PLAN COMMISSION MEETING AGENDA

TUESDAY, February 25, 2014
AT 6:00 P.M.

PROJECT: Sign and Light Plan Review – Drexel Town Square

PROJECT: Site Plan Review – Four Points by Sheraton

Sheet Title
SITE LAYOUT AND MATERIALS PLAN

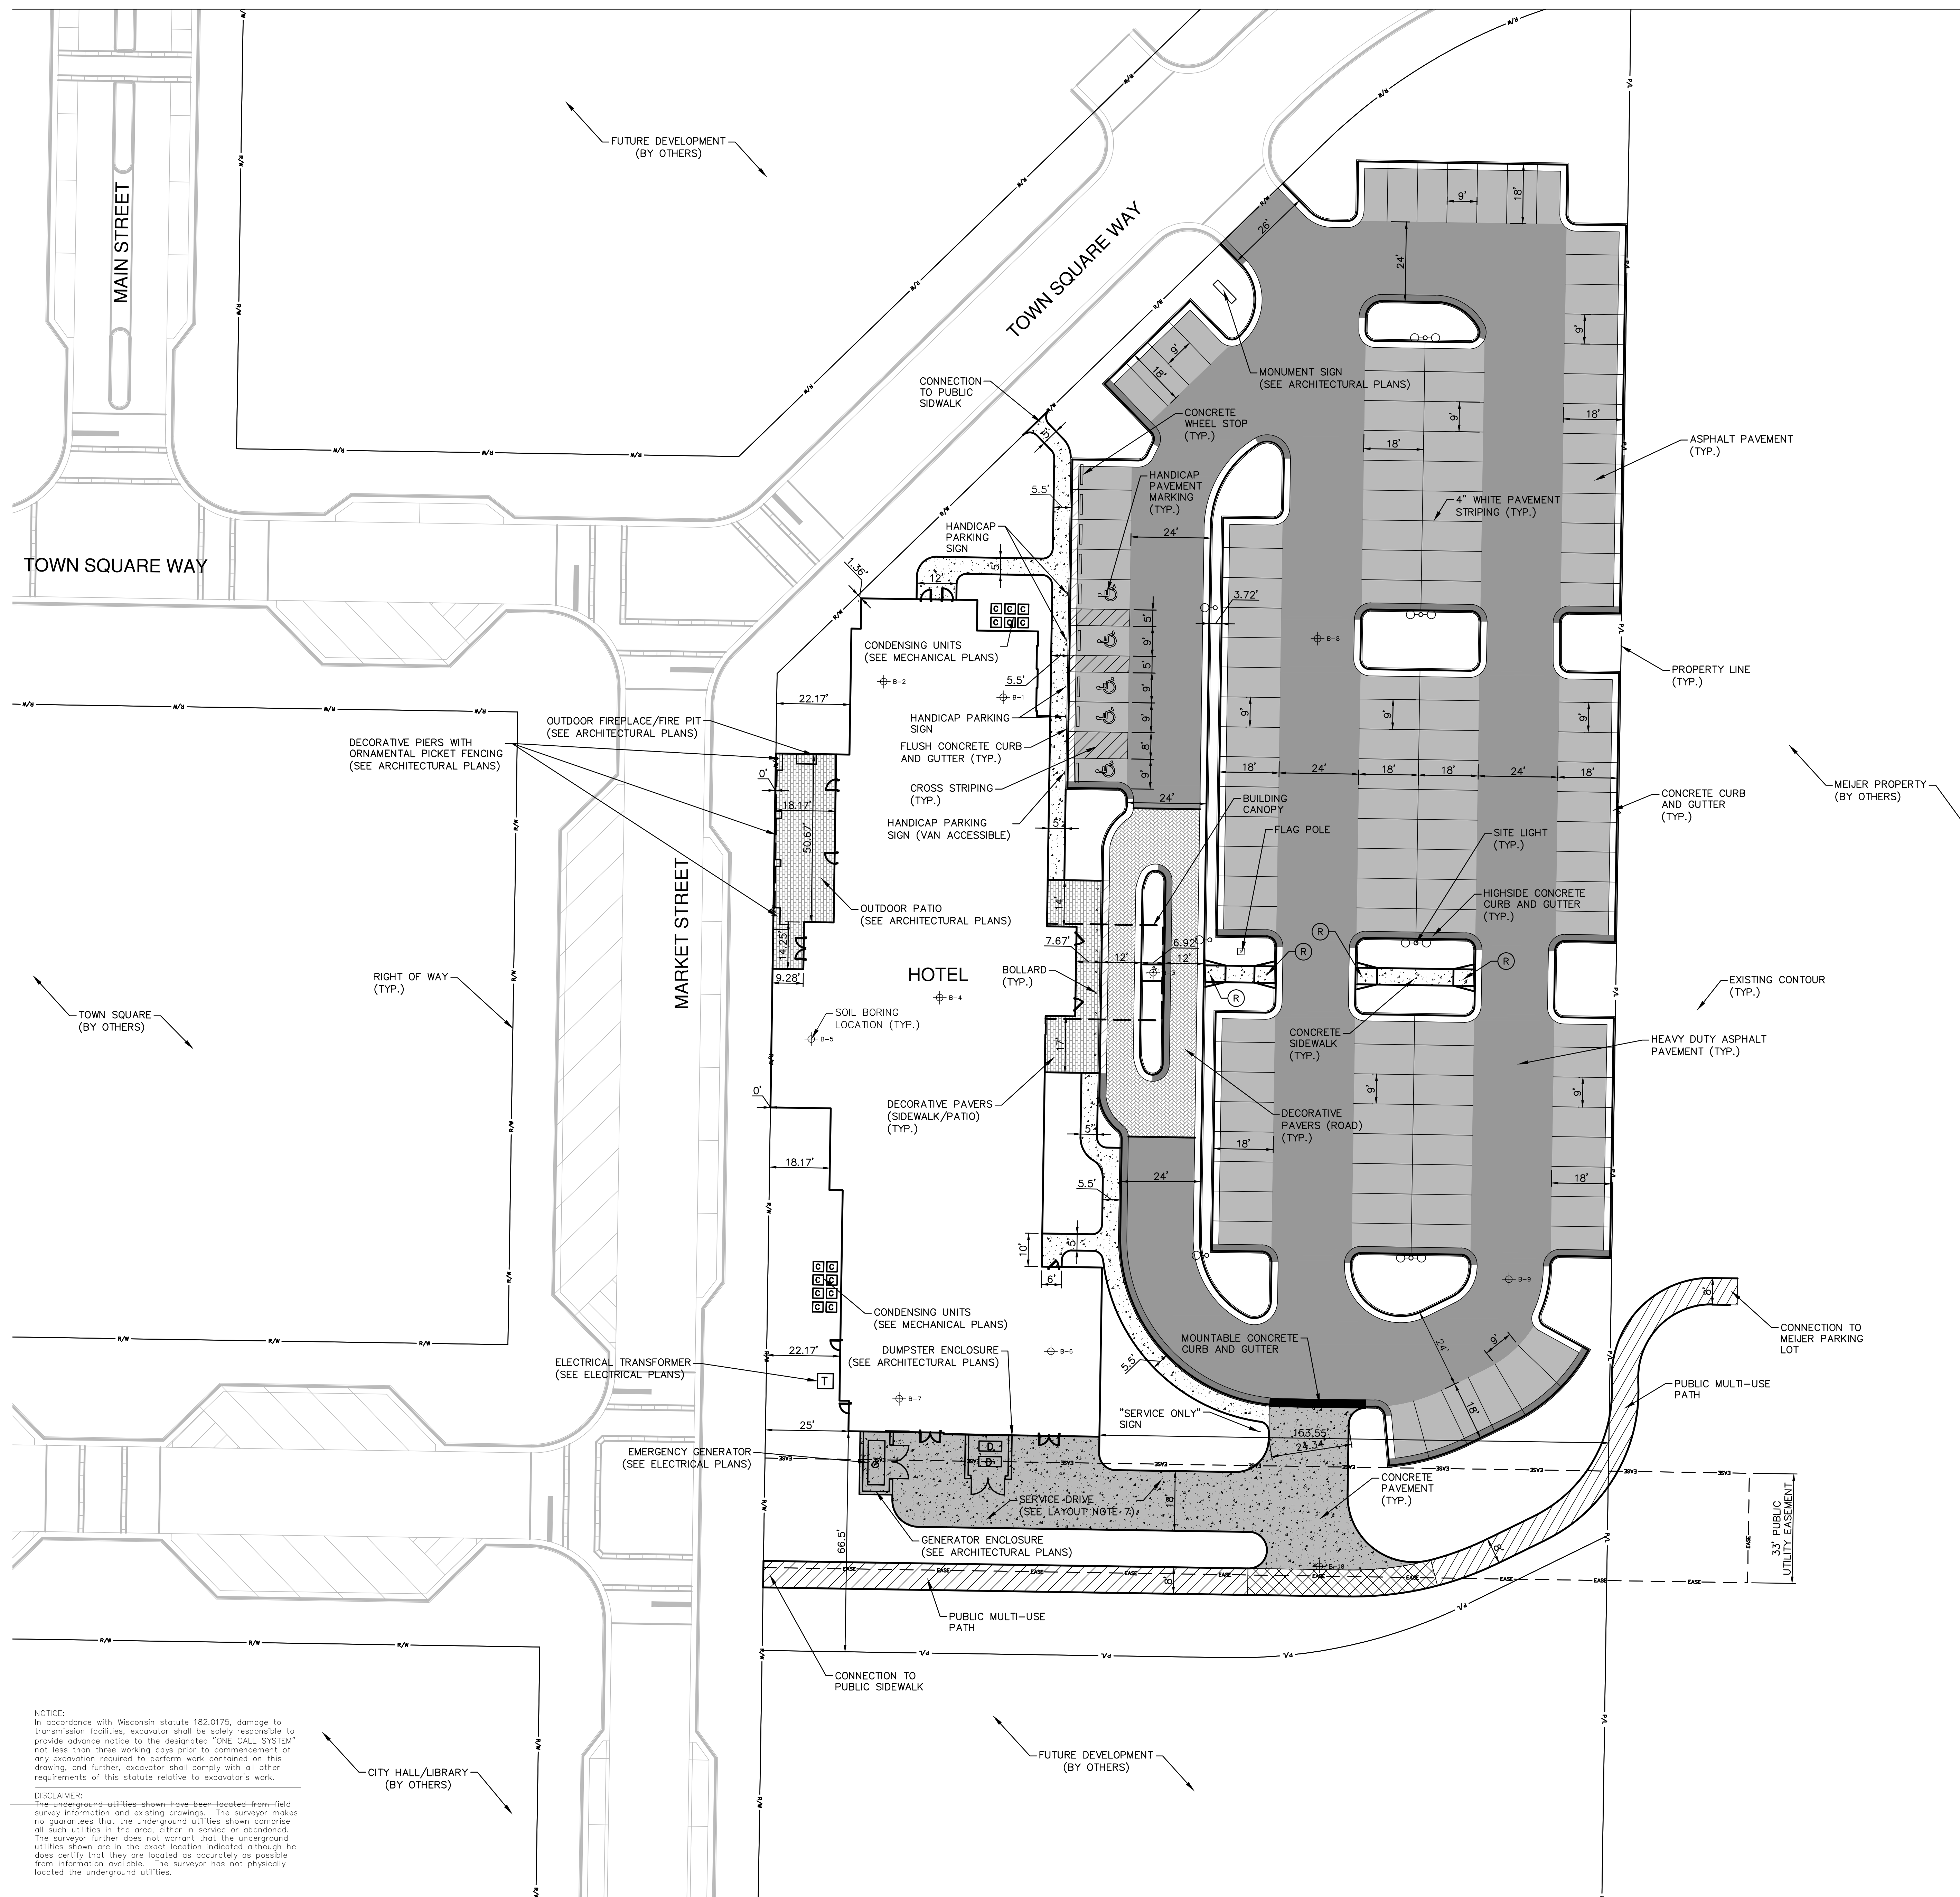
1. That the plans are revised to remove encroachments into the utility easement.
2. That the plans are revised to include the 5-foot landscape zone along the east property line.

3. That details for the trash and generator enclosure gates are provided for review and approval of the Department of Community Development.
4. That the plans are revised to eliminate the concrete connection from the service drive to the public pedestrian path on the south, and to show a connection to the approved location of the public pedestrian path on the Meijer property to the east.

Access to the service areas will be via a driveway (24.34 feet in width at the mountable curb) that is 18 feet in width. It also includes a concrete connection to the public pedestrian path. This should be eliminated. If a stub is required for a service vehicle turnaround, the pavement should stop with enough distance to the public pedestrian path such that screening can be added. This is for pedestrian safety as well as for aesthetics. The applicant should also ensure that the location of the pedestrian path on the hotel property coincides with the location of the pedestrian path on the adjacent property (Meijer).

Sheet Title
**ELECTRICAL
SITE
LIGHTING
PLAN**

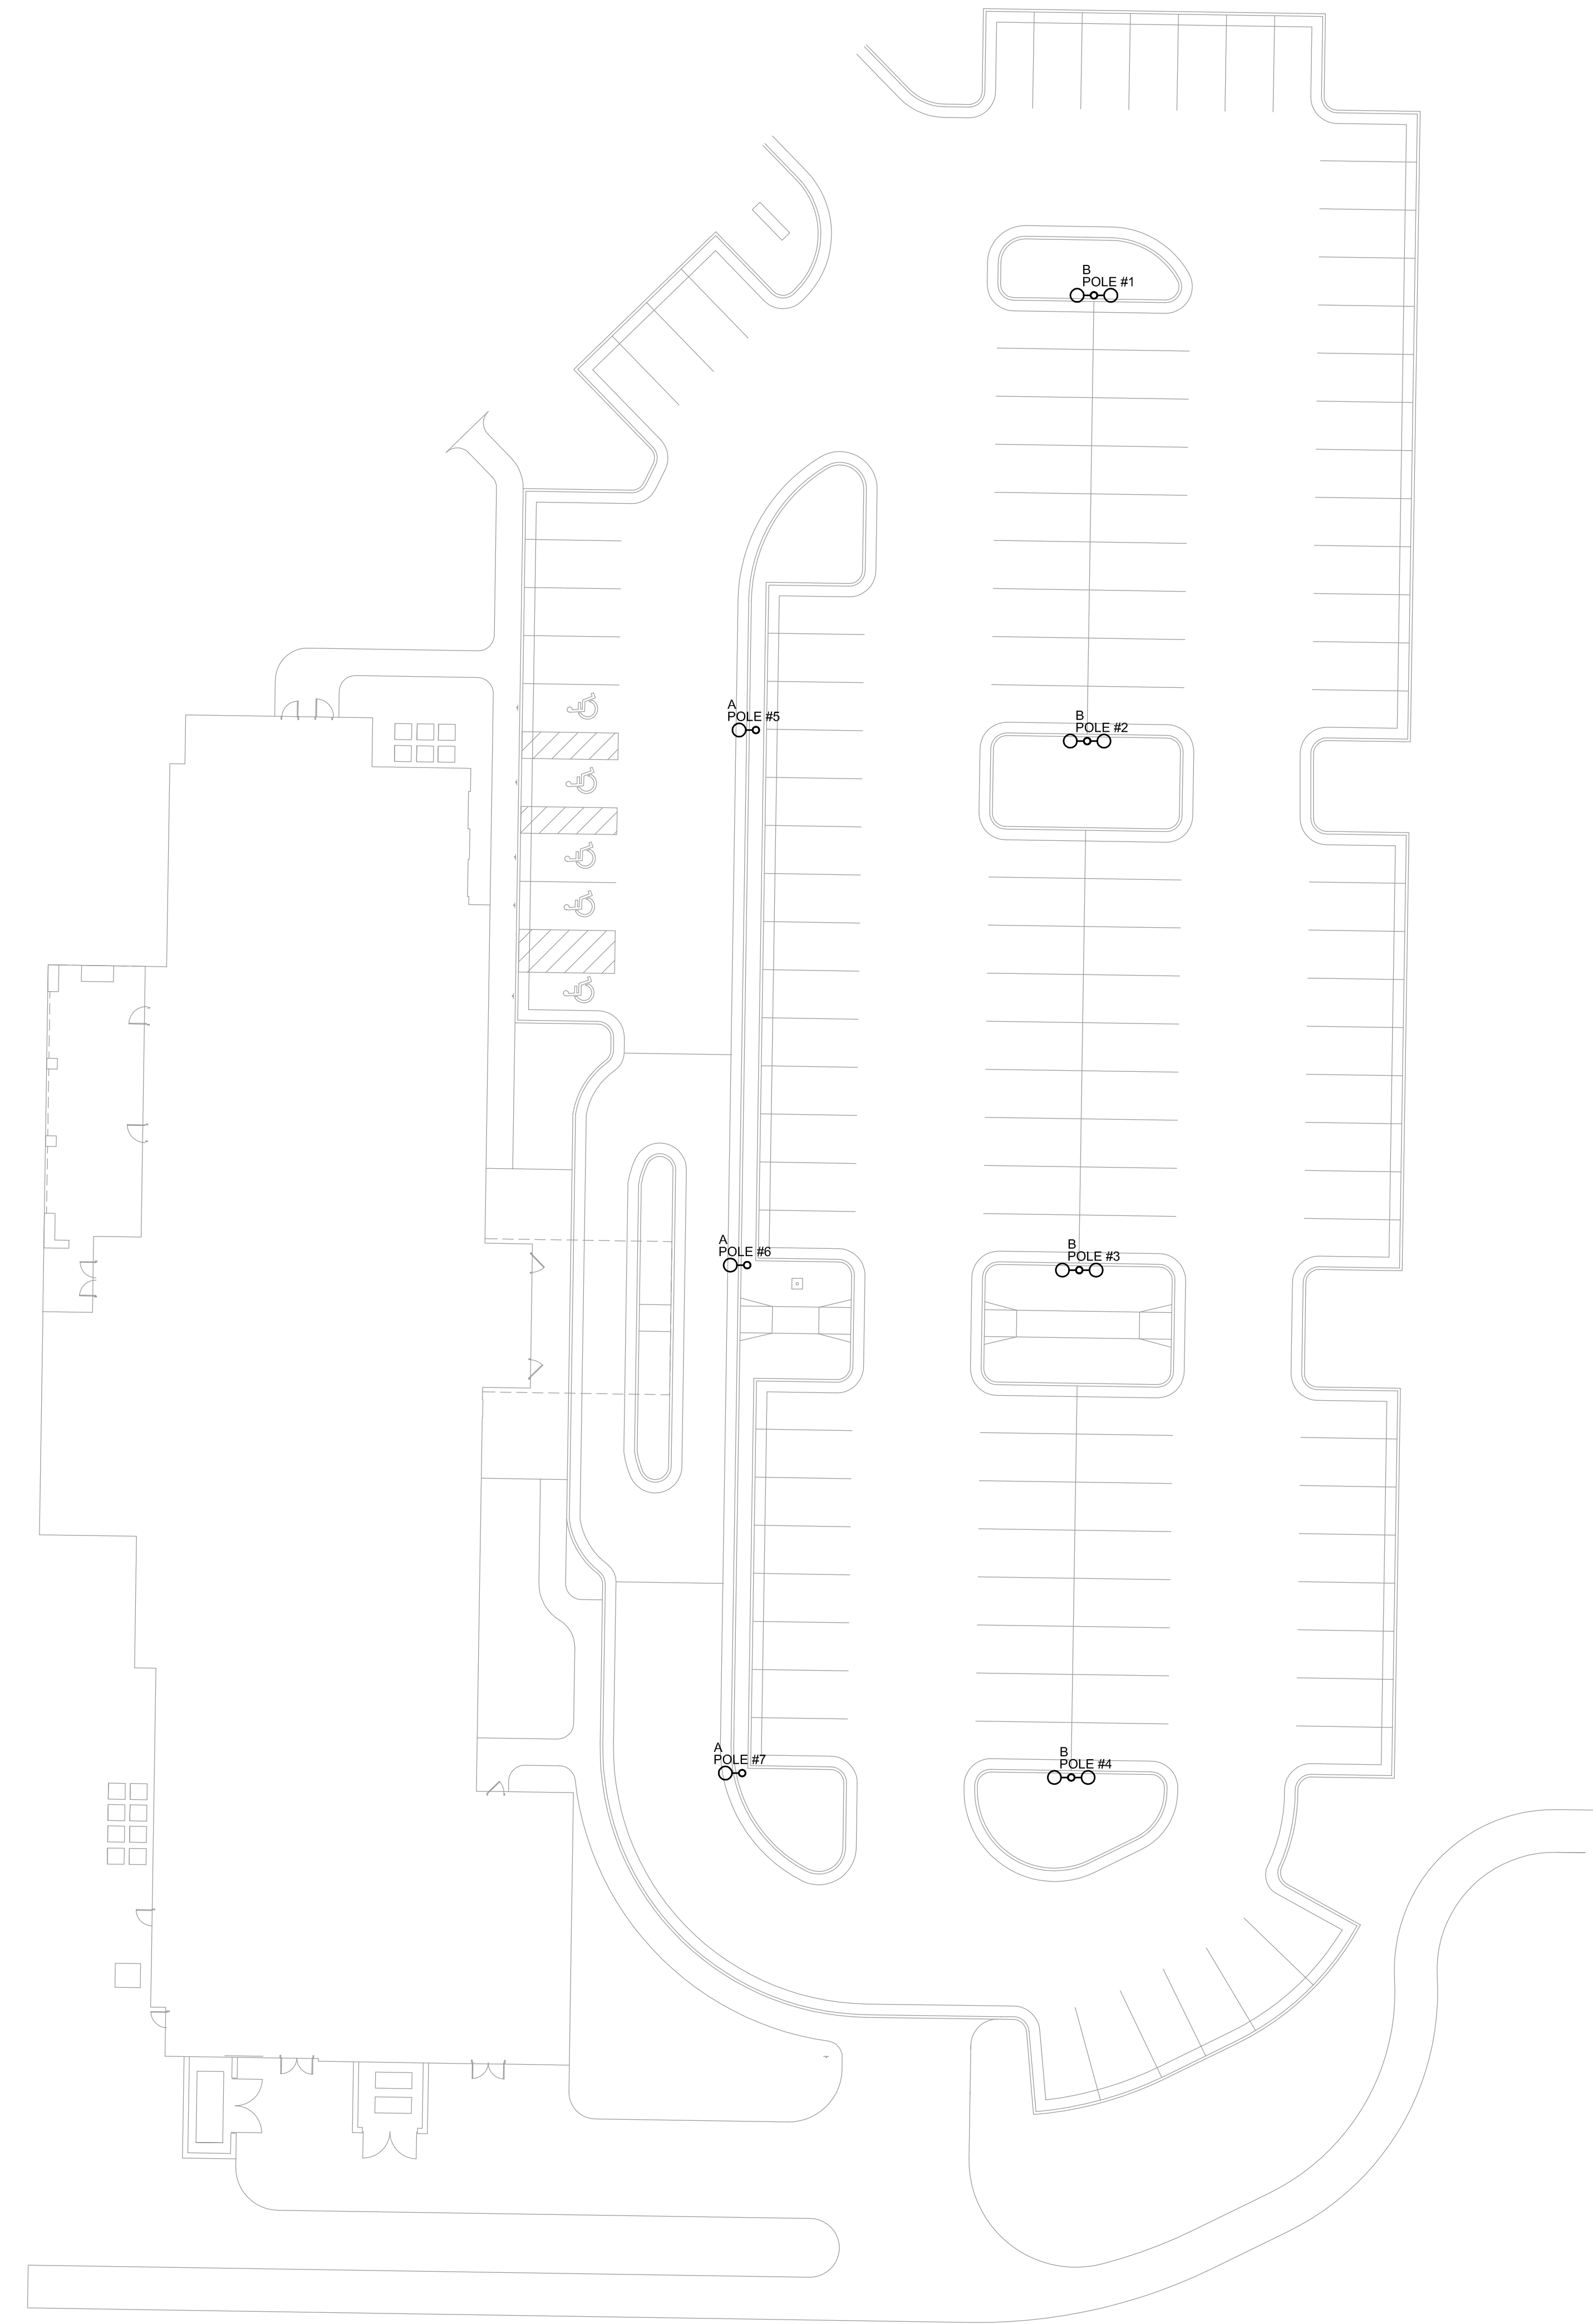
Lighting photometric plans for the parking lot have been submitted and are included in your packets. There will be seven (7) poles within the parking lot, which will be 27 feet tall with LED fixtures that produce 4000K ("neutral white"). Although this plan has received preliminary review, it will need to be approved by the Electrical Inspector prior to the issuance of building permits. Additional lighting details (building, patio, decorative, etc.) will need to be submitted for review and approval by the Plan Commission or designee (Director of Community Development and Electrical Inspector).

7. That detailed lighting plans (including parking lot, building lighting, and pedestrian-level lighting) be approved by the Plan Commission (or Director of Community Development), upon recommendation of the Electrical Inspector, prior to the issuance of building permits.
